HISTORIC PRESERVATION COMMISSION

REQUEST FOR CERTIFICATE OF APPROPRIATENESS

MPC File No.: 26-002739-COA

Address: 413 West 39th Street

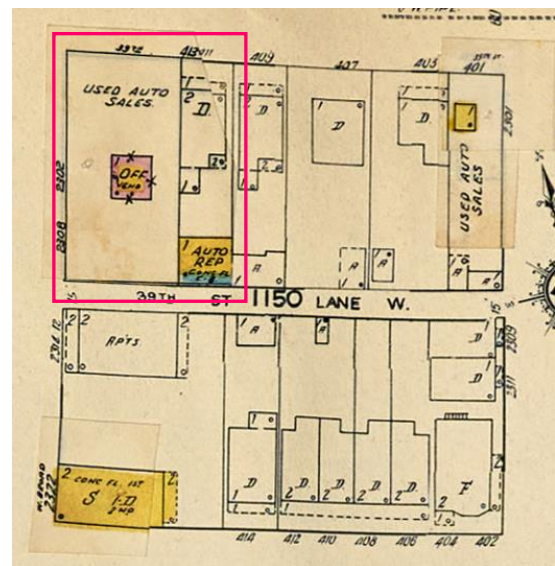
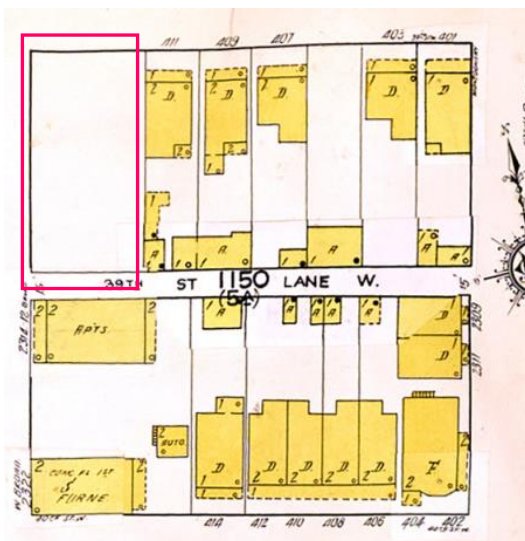
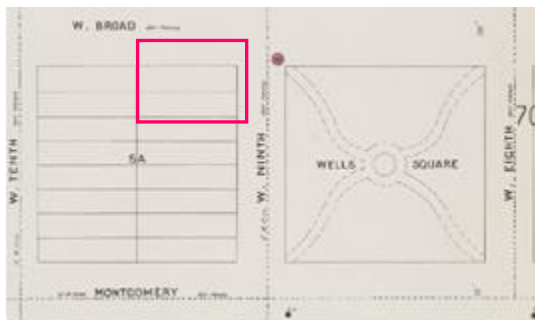
Currently there is one large lot with two non-contributing structures built in 1951. The former auto shop business is no longer operating, and the buildings are sitting vacant. If the demolition is approved, this will allow for the lot to be split into three separate lots that would be intended to each contain one duplex and one ADU. The current configuration of the lot is shown in the image.
